**ADDENDUM NO. 02
DATED AUGUST 26, 2019**

EAST SIDE UNION HIGH SCHOOL DISTRICT PIEDMONT HILLS HIGH SCHOOL

PLAY COURT IMPROVEMENTS PROJECT NO. Z-045-705

BID SCHEDULE **(ADDENDUM NO. 2)**
 FOR
PIEDMONT HILLS HIGH SCHOOL
DW INFRASTRUCTURE - PLAY COURT IMPROVEMENTS
PROJECT NO. Z-045-705

ENLARGEMENT A
1" = 20'

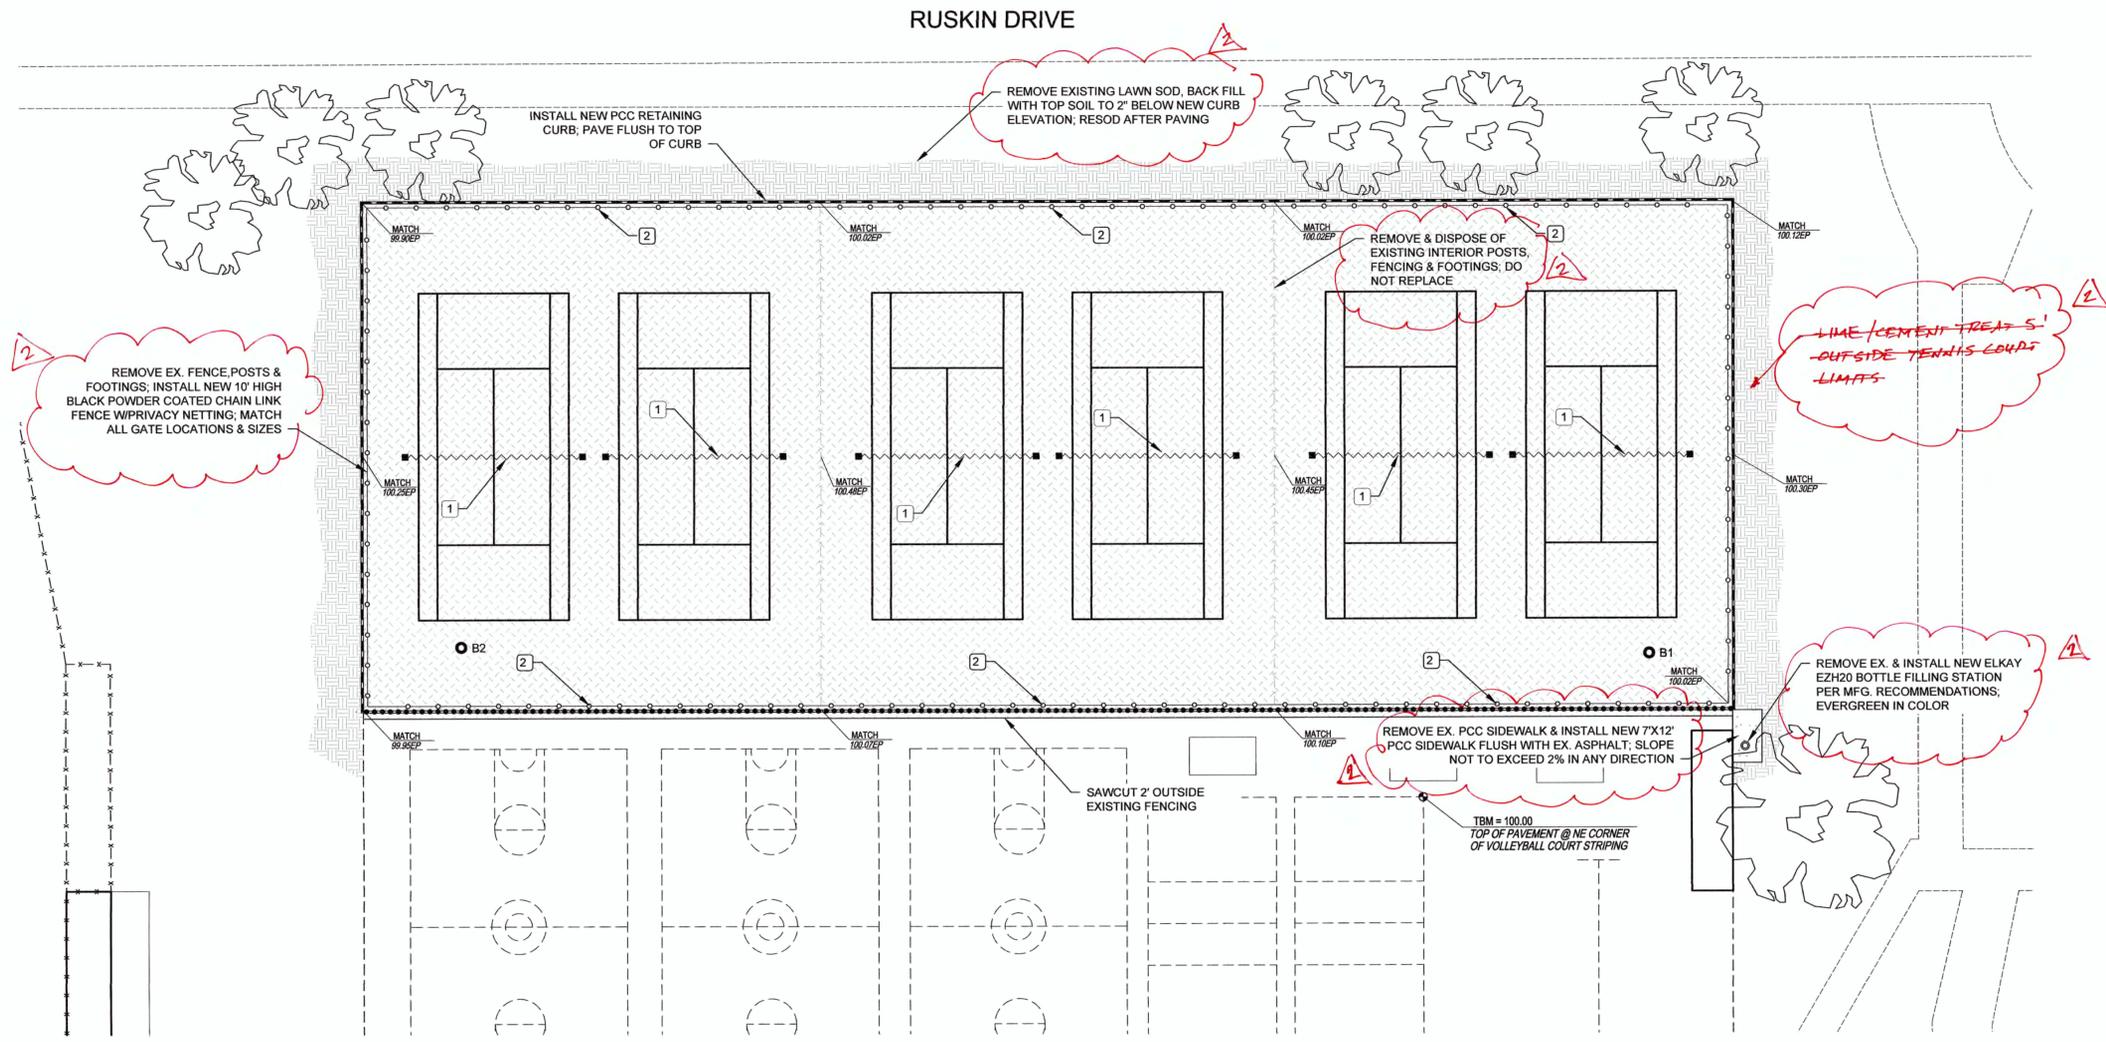
- Reference the answer on Question 5 on Addendum No. 01, replace entirely with the answer below on this Addendum No. 02.
Answer: See Note No. 1 on Sheet 2 of 3 of the Construction Drawings.

- 1 CONTRACTOR SHALL REMOVE & DISPOSE OF EX. TENNIS COURT HARDWARE, POST & POST BASES. CONTRACTOR SHALL INSTALL NEW PW ATHLETIC TENNIS COURT HARDWARE MODEL NO. 2205-GR (POSTS), MODEL 8352 (PREMIUM TENNIS NET), MODEL NO. 8371-20 (GROUND ANCHOR), MODEL 8371-30 (NET TIE DOWN STRAP), AND ALL OTHER MFG. REQUIRED PARTS FOR INSTALLATION. INSTALL PER MFG. RECOMMENDATIONS.
- 2 INSTALL WEATHER PROOF ELECTRICAL OUTLETS, FASTEN TO FENCE POST.
